SUNDRY NOTICES AND REPORTS ON WELLS

PLUG AND ABANDONMENT PROCEDURE

Valencia Canyon Unit #10

Re: Permanent Abandonment
Well: Valencia Canyon Unit #10

Proposed P&A

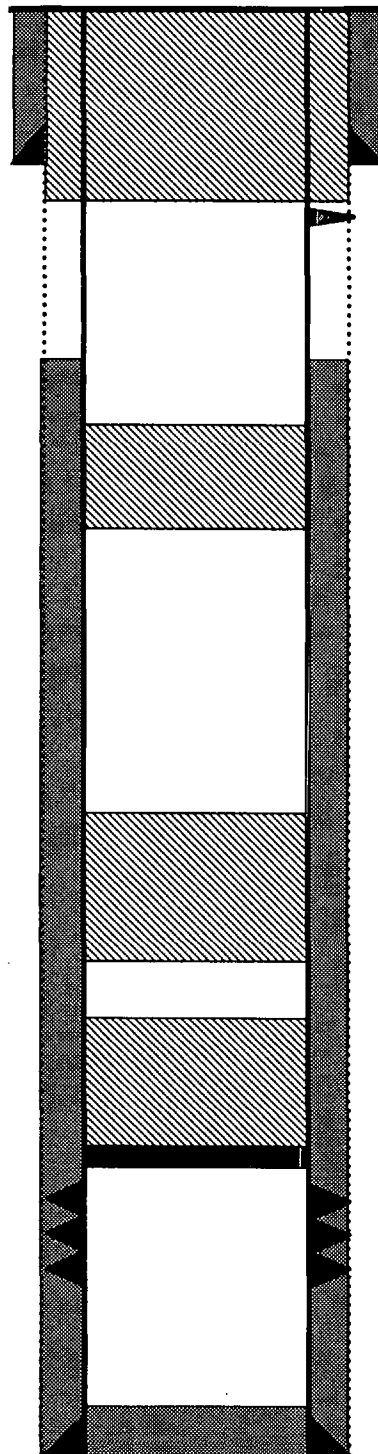
Extend top of Ojo Alamo plug to 3400 feet

1. Plugging operations authorized are subject to the attached "General Requirements for Permanent Abandonment of Wells on Federal and Indian Lease."
2. Farmington Office is to be notified at least 24 hours before the plugging operations commence (505) 564-7750.
3. The following modifications to your plugging program are to be made:
 - a) Adjust the placement of plug #2 (3816-3526) ft. to cover the Kirtland and Ojo Alamo tops. Adjust cement volume accordingly.
 - b) Bring the top of plug #3 to 2277 ft. to cover the Nacimiento top. Adjust cement volume accordingly.

Operator will run a CBL to verify cement top. Outside plugs will be required if cement top is not adequate for zonal isolation. Submit electronic copy of the log for verification to the following BLM address: tsalyers@blm.gov

See CoA

See CoA
